FILE PI No. 0010925, Fulton County
I-285 Ramps @ CR 209/Riverside Drive
Design-Build

SUBJECT **Project Information Transmittal to the Office of Engineering Services**

Pavement Design Package Quality Assurance Review Sheet					Mgmt Let Date:	11/15/2015
PI No:	0010925	Project No:	0010925		Submitted by:	IPD
County:	Fulton	SR:	N/A		Date Received:	5/5/2014
OPD PM:	Marlo Clowers	WFTK:			CST Funding:	$2,080,800.00
Full Depth Concrete:	1	Overlay Asphalt:	1		Full Depth Asphalt:	1
Overlay Concrete:	N/A	Traffic Data:	2015/2035		Pavement Eval Summary:	Not Included
VE Study Immplementation:	N/A	Soil Survey:	N/A		Pavement Type Selection:	3/11/2010

Subject:
Riverside Drive Roundabouts Pavement Design Package Quality Assurance Review Consultant Responses
PI No. 0010925

DRAWING No. 01-001

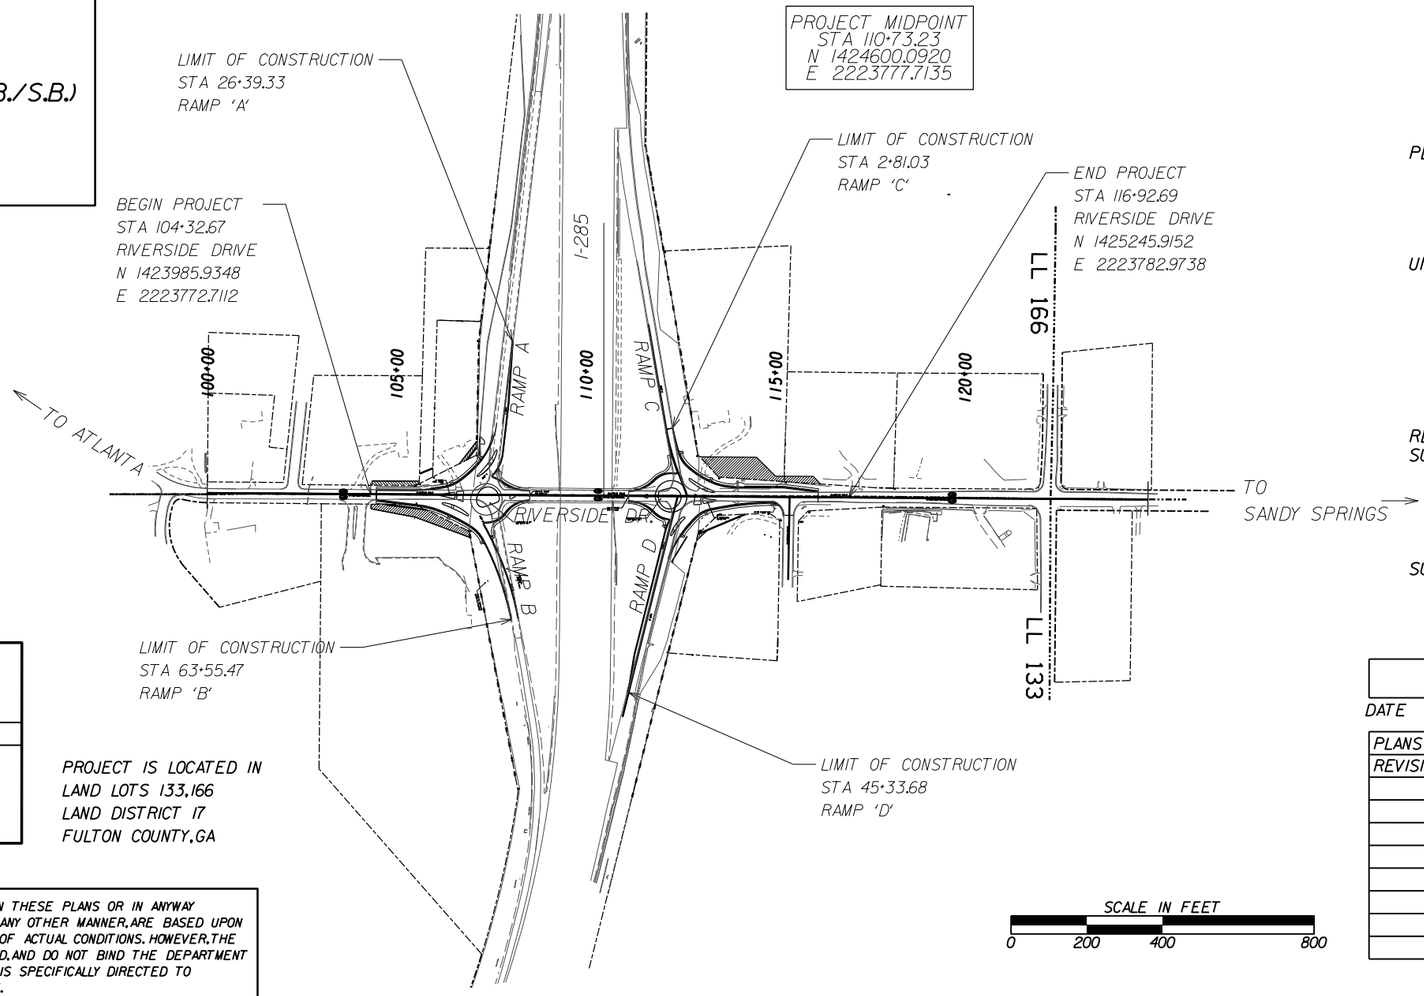
1. Show the begin/end location for the Ramp A - D construction.
    - ARCADIS Response: Limit of construction labels will be added to the cover sheet for all ramps.

TYPICAL SECTION
RIVERSIDE DRIVE ROUNDABOUT
(SEE GDOT CONSTR. DETAIL RA-2)

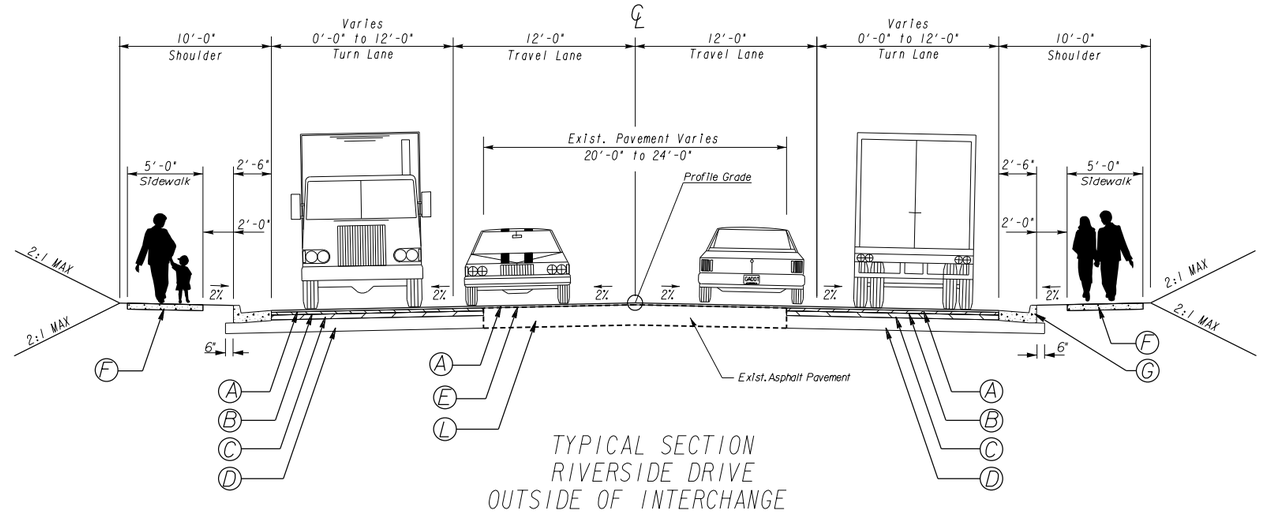
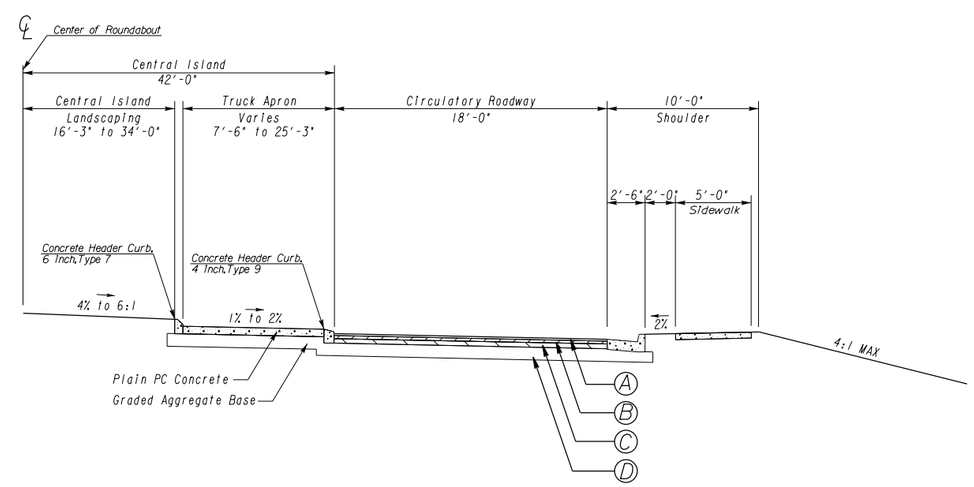
5. The Riverside Dr. mainline and roundabout typical sections show different thicknesses for the 25mm layer (Label C).
    - ARCADIS Response: The thickness of the 25mm pavement layer will be revised to be consistent between the Riverside Drive typical section and the roundabout typical section.

4. Milling is shown on the overlay design but is not shown on the overlay typical sections; E.g. Riverside Dr. typical Section.
    - ARCADIS Response: Milling will be shown on the Riverside Drive overlay typical section

TYPICAL SECTION
I-285 ENTRANCE RAMPS

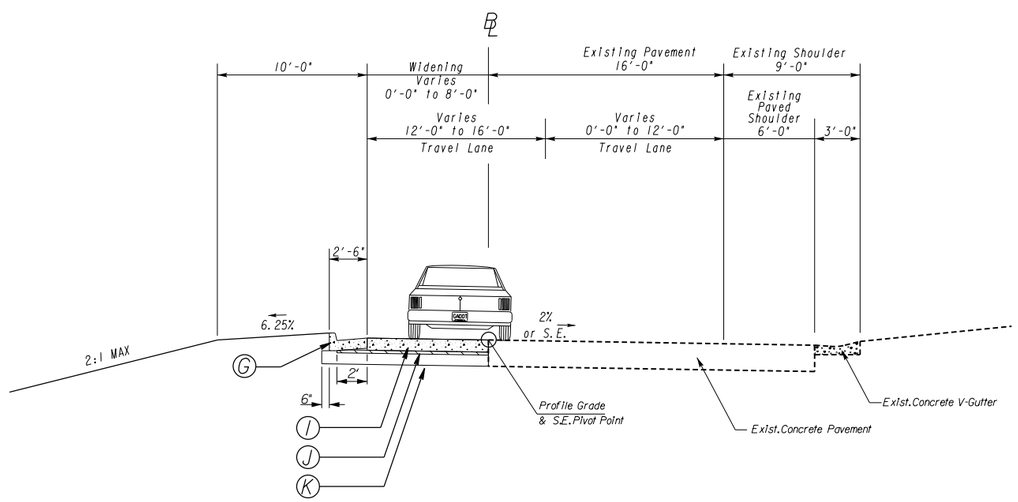
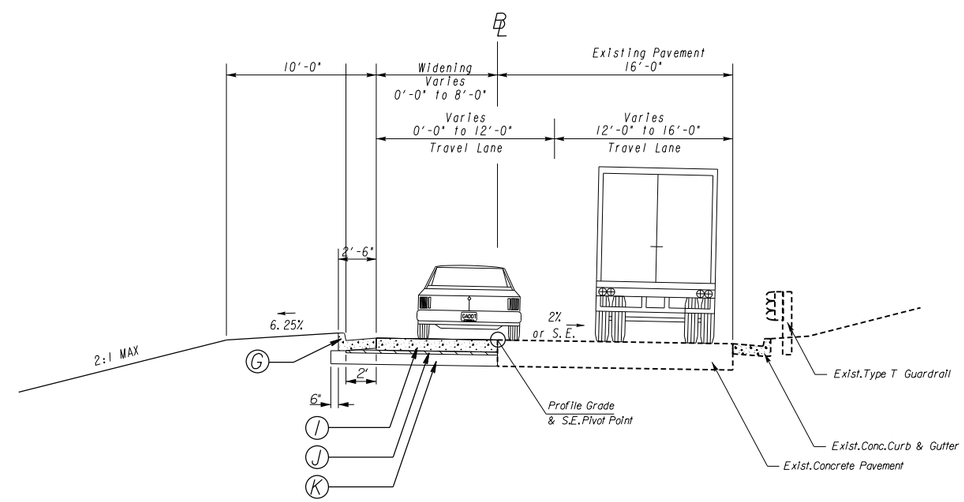
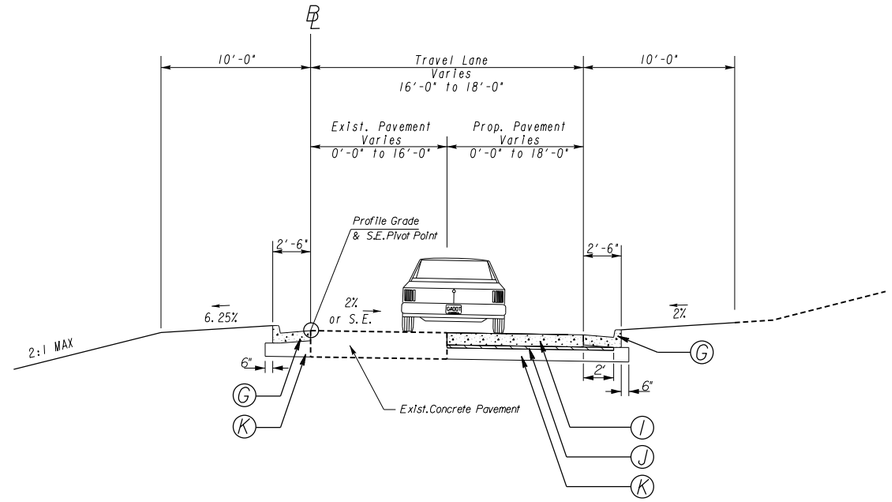
10. The ramps should not be constructed with CRCP as the design analysis reflects. Use JPCP to construct the ramps; which the typical sections and the project description show.

- ARCADIS Response: The ramp pavement design will be updated to show JPCP
11. Separate ramp designs can be proposed if desired to possibly save on the construction material costs; since each ramp has different traffic data.
